## ORIGINATION FORM

Proposed Revisions to a Standard Plans Index  
(Please provide all information — Incomplete forms will be returned)

Index Number: 700-041  
Sheet Number (s): 2 of 5  
Index Title: Span Sign Structure

BASE PLATE CONNECTION

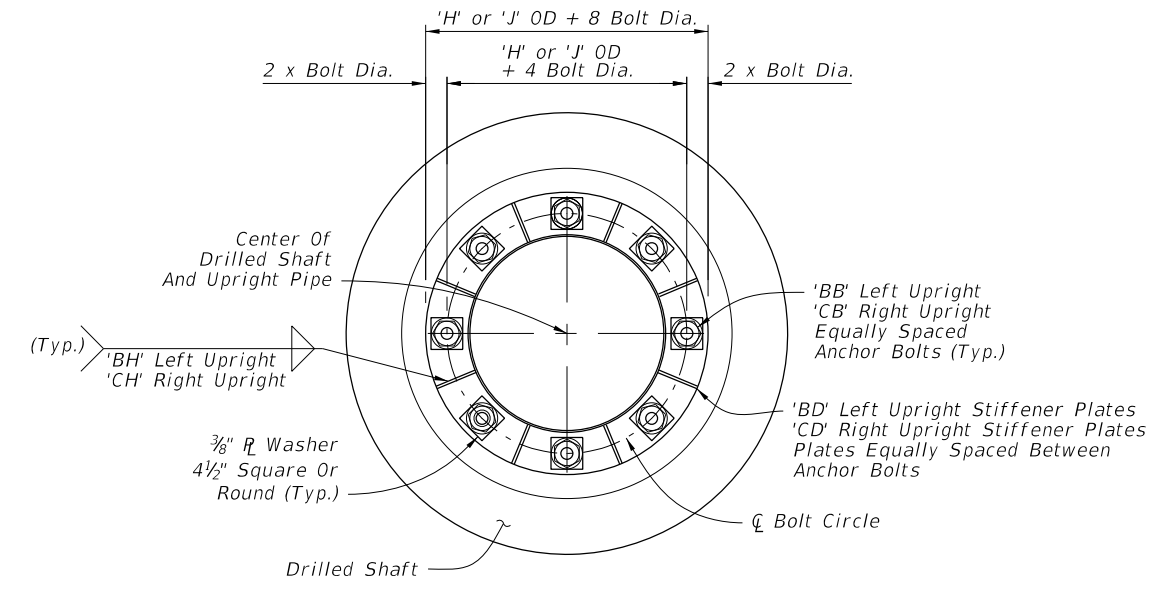
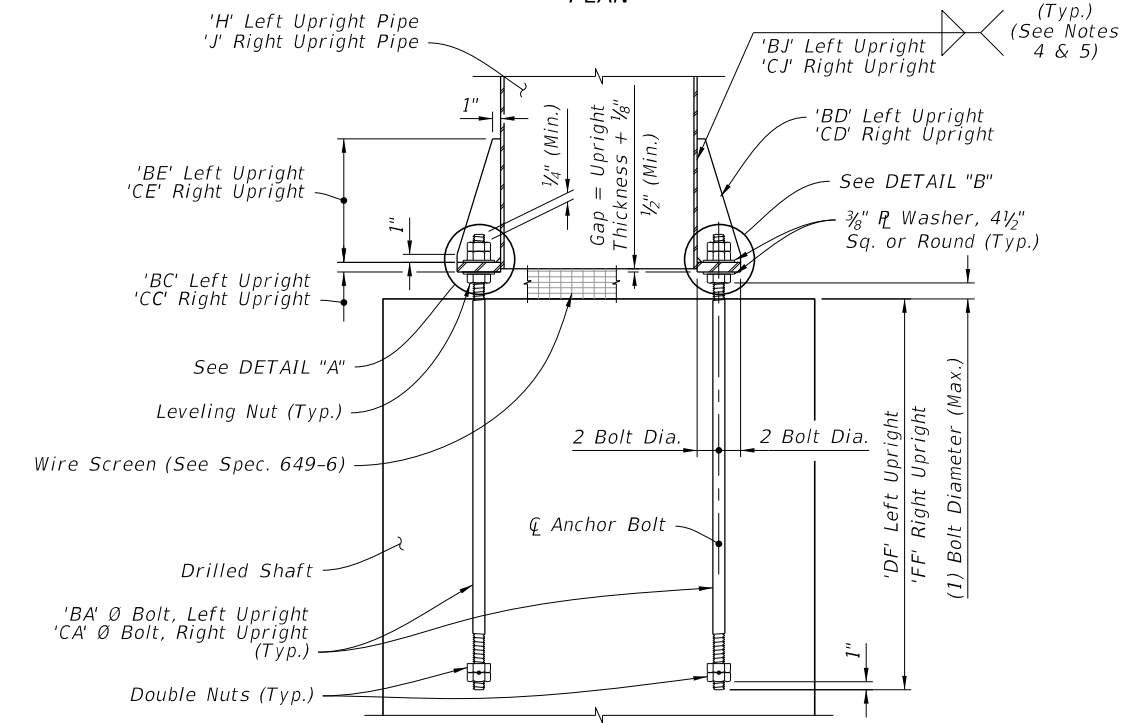
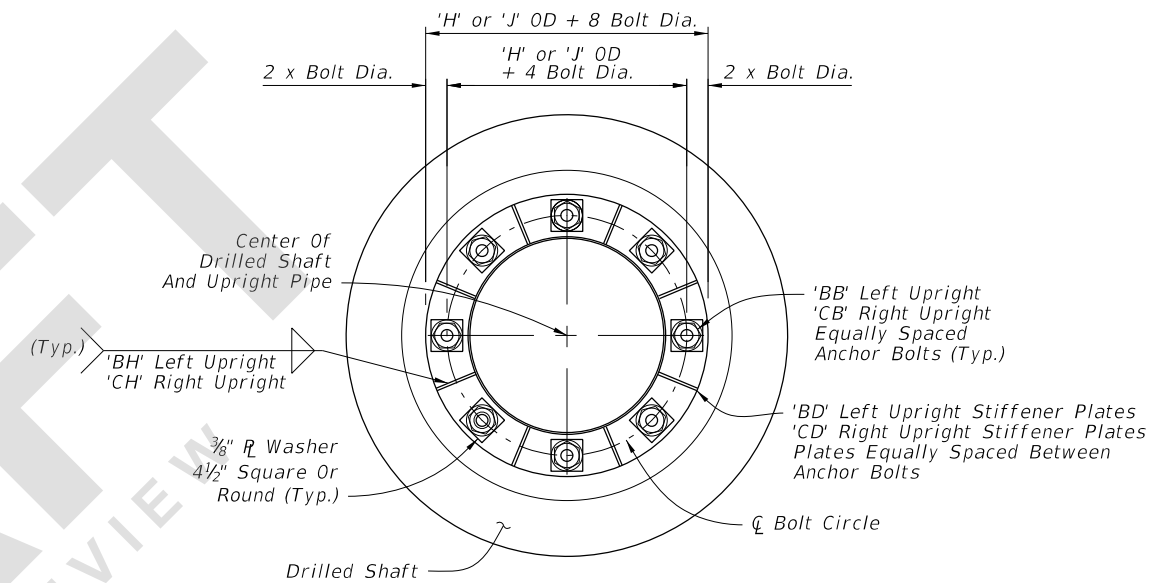
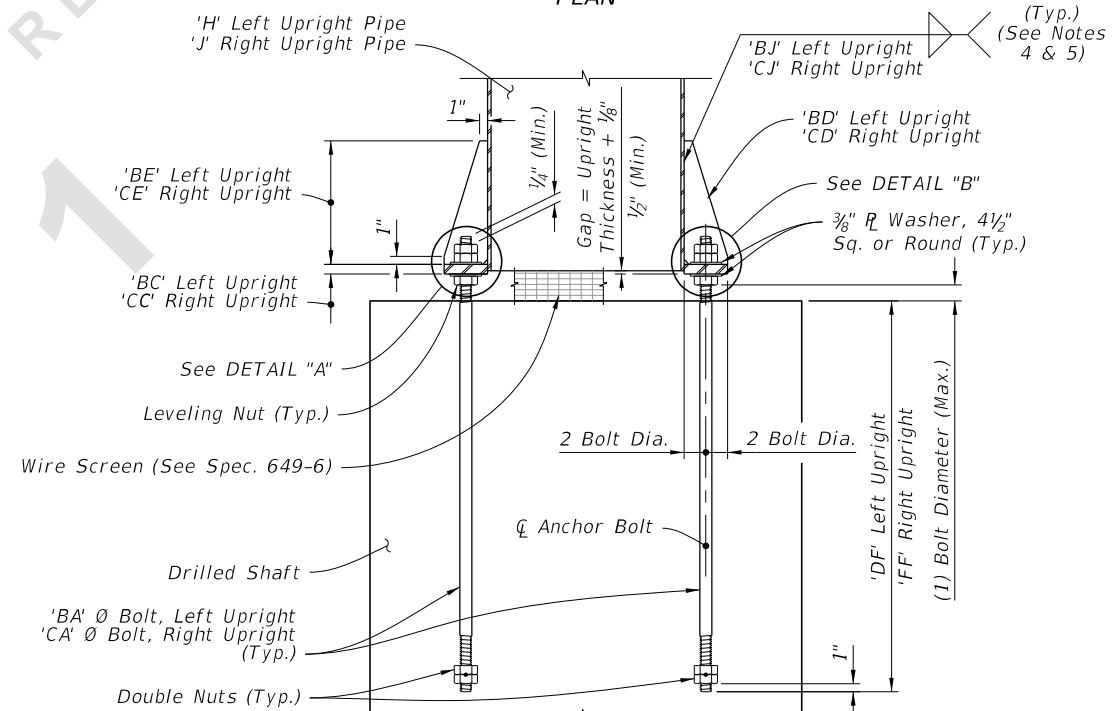
Revised Note 5 to read "After galvanizing, provide magnetic partial testing on 100% of upright fillet welds."

During maintenance inspections, weld cracks were found on in-service overhead sign structure supports. A FDOT investigation determined the cracks were formed during fabrication. To implement a better fabrication quality control processes, the note on the Standard is being changed.

- NOTES:**
1. See Traffic Plans for elevation at top of Foundation.
  2. Install Drilled Shaft with a 2'-0" minimum from top elevation of the drill shaft to the finished grade, unless specified otherwise in the plans.
  3. The shaft length is based on 2'-0" height above finished grade.
  4. Wrap fillet weld around the stiffener termination on the tube wall (Typ).
  5. ~~Provide ultrasonic testing for Lamellar Tearing when wall thickness exceeds 1/2"~~

After galvanizing, provide magnetic partial testing on 100% of upright fillet welds.

- NOTES:**
1. See Traffic Plans for elevation at top of Foundation.
  2. Install Drilled Shaft with a 2'-0" minimum from top elevation of the drill shaft to the finished grade, unless specified otherwise in the plans.
  3. The shaft length is based on 2'-0" height above finished grade.
  4. Wrap fillet weld around the stiffener termination on the tube wall (Typ).
  5. After galvanizing, provide magnetic partial testing on 100% of upright fillet welds.
